Docket Item #8
BAR CASE# 2005-00107

BAR Meeting
July 27, 2005

ISSUE: New condominium building

LOCATION: 1115 Cameron Street & 200 North Henry Street

Figure 3 - Henry Street Facade

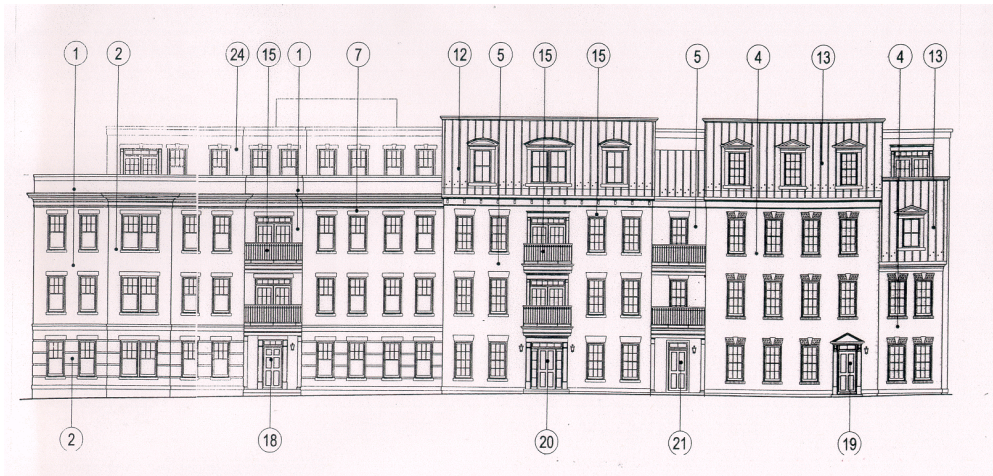
17. That all the windows be two-over-two;
18. That the french doors be revised to correspond to the window configuration;

19. That the hyphen windows be changed to two-over-two;

20. That the door be changed to a six panel door;
21. That the transom have three or more lights;

22. That the applicant work with Staff to further refine the treatment of the sills and lintels;

23. That the dormer window in the addition be six-over-six;

Figure 4 - Fayette Street Facade

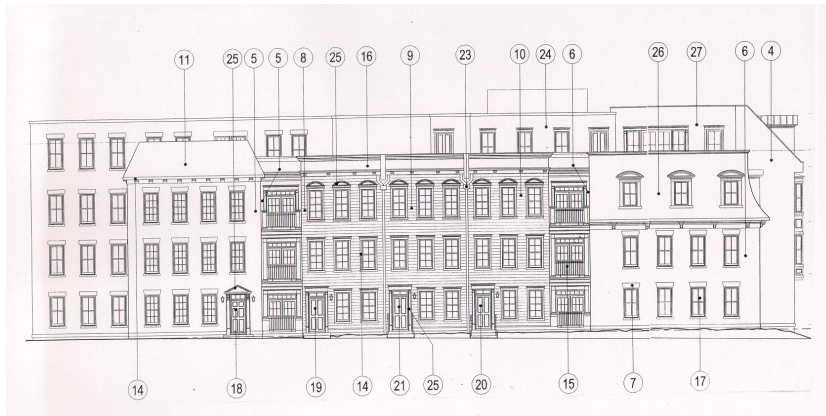
24. That the curve of the mansard roof be slightly straighter;
25. That the applicant work with Staff to investigate whether it is feasible to wrap the mansard at the north end;

26. That the parapet terminate in a corbel rather than a soldier course;

27. That the fiber cement siding be smooth (not wood grained), and installed so that the nails are not visible;
28. That the fiber cement siding have no greater than a 5" reveal;
29. That the segmental arches be eliminated from the third story windows;

30. That the parapet terminate in a corbel rather than a soldier course;

31. That the roof be faux slate or metal; and,
32. That the applicant provide Staff with enlarged details of the cornice, door surround and window lintels and sills for review and approval.
